Proposal for a supplement to the 12 series of amendments to UN Regulation No. 13 (Heavy vehicle braking)

Submitted by the expert from the European Association of Automotive Suppliers

The text reproduced below was prepared by the expert from the European Association of Automotive Suppliers (CLEPA) to include in UN Regulation No. 13 requirements for the type approval of Electro-Mechanical Braking (EMB) systems as state-of-the-art braking systems. This document supersedes ECE/TRANS/WP.29/GRVA/2021/24 and informal document GRVA-13-05.

(ac) Paragraph 5.2.1.35.3.

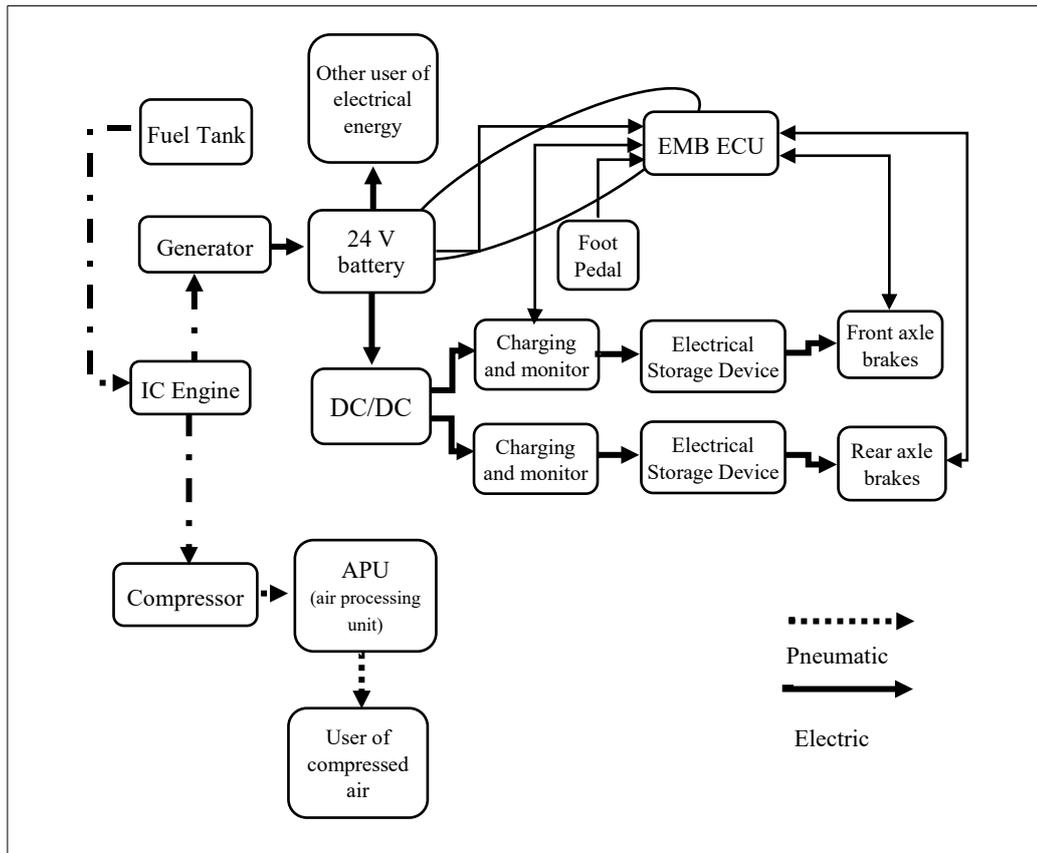
46 In order to avoid design restrictive requirements, manufacturers are required to provide documentation on the parameters and a description of the function triggering these warnings.

(af) Paragraph 5.2.1.35.6.

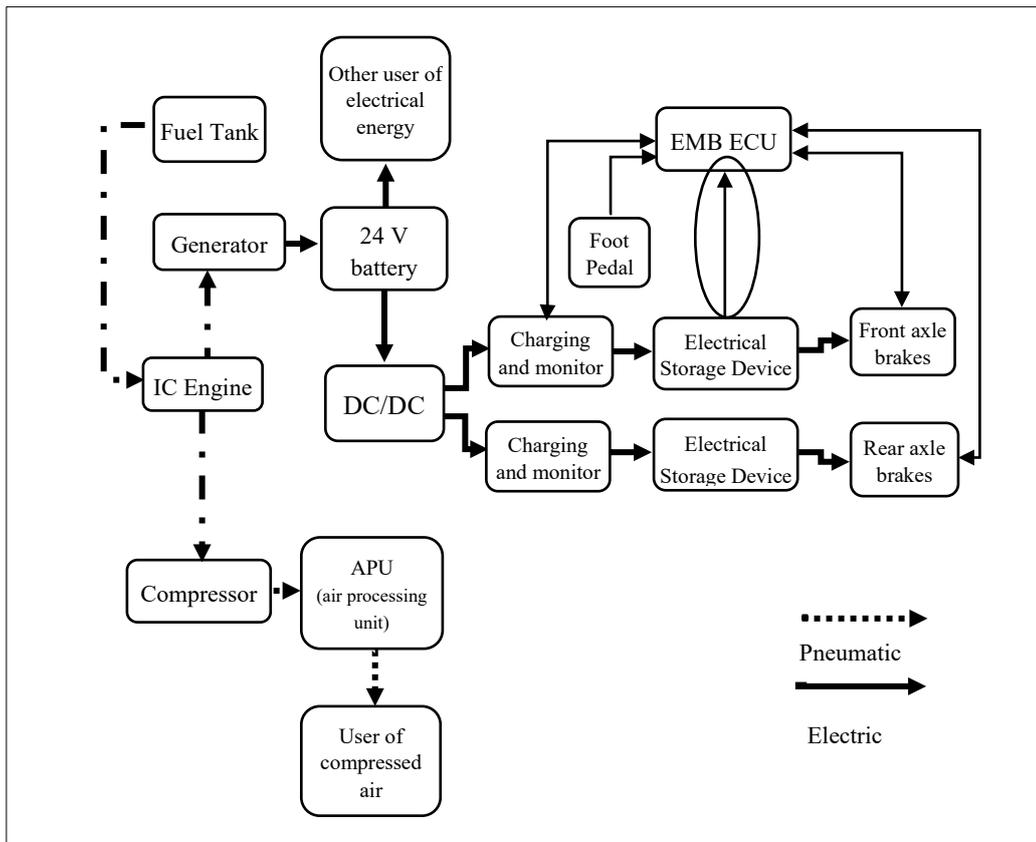
50. In contrast to paragraph 5.2.1.35.5., this requirement addresses a configuration of an electro-mechanical braking system where energy storage devices are providing electrical energy for the electrical control and electrical energy transmission); as an exemplary simplified braking system see figure below.
